Access Compliance Report

Public Rights-of-Way

(Curb Ramps)

Intersection ID: 10003849	Main Street: DIXIE_RIVER_RD	Cross Street: NEW_FASHION_WY	Location: NE
ADA ID: 9AB72A668DF4	Ramp Type: Perp	Initial Pass/Fail: Fail	Overall Compliance: No
Severity Score: 12.5			
Codes/Mitigation Info/Possible Solution		Field Measurements/Component Compliance

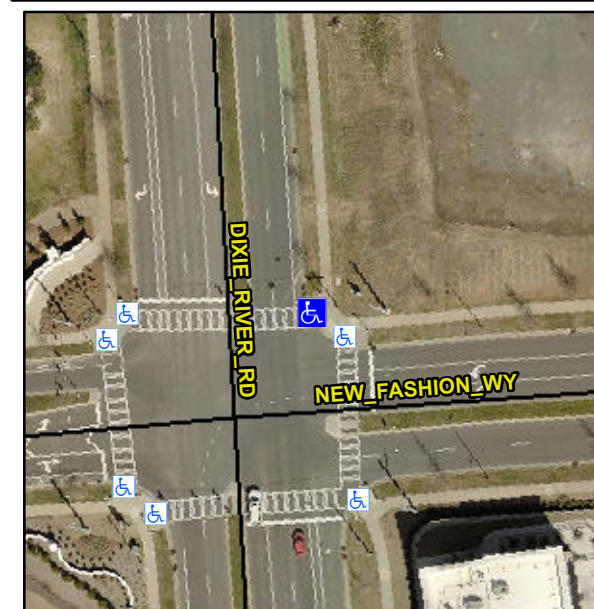
Not Found, R304.2.2

Compliance	Description	Data	Compliance	Description	Data
N/A	Ramp Length (in)	71.0	No	Ramp Slope (%)	8.5
Yes	Ramp Width (in)	48.0	Yes	Ramp XSlope (%)	0.4
N/A	Flare Type LT	N/A	N/A	Flare Type RT	N/A
N/A	Flare Slope LT (%)	N/A	N/A	Flare Slope RT (%)	N/A
N/A	Flare Traversable LT?	N/A	N/A	Flare Traversable RT?	N/A
N/A	Landing Length (in)	N/A	N/A	DWS Provided?	N/A
N/A	Landing Width (in)	N/A	N/A	DWS Contrast?	N/A
N/A	Landing Slope (%)	N/A	N/A	DWS Length (in)	N/A
N/A	Landing X Slope (%)	N/A	N/A	DWS Full Width?	N/A
N/A	Landing Curb? (Y/N)	N/A	N/A	DWS Offset (in)	N/A
N/A	Shared Landing?	N/A			
N/A	Gutter Ponding?	N/A	N/A	Gutter Slope (%)	N/A
N/A	Gutter Lip Ht (in)	N/A	N/A	Gutter X Slope (%)	N/A
N/A	Painted X Walk1?	Yes	N/A	Painted X Walk2?	N/A
	X Walk 1 Direction	To W		X Walk 2 Direction	N/A
N/A	X Walk 1 Width (in)	113.0	N/A	X Walk 2 Width (in)	N/A
	X Walk 1 Slope (%)	0.8		X Walk 2 Slope (%)	N/A
	X Walk 1 X Slope (%)	0.7		X Walk 2 X Slope (%)	N/A

Remove & Replace Entire Ramp.
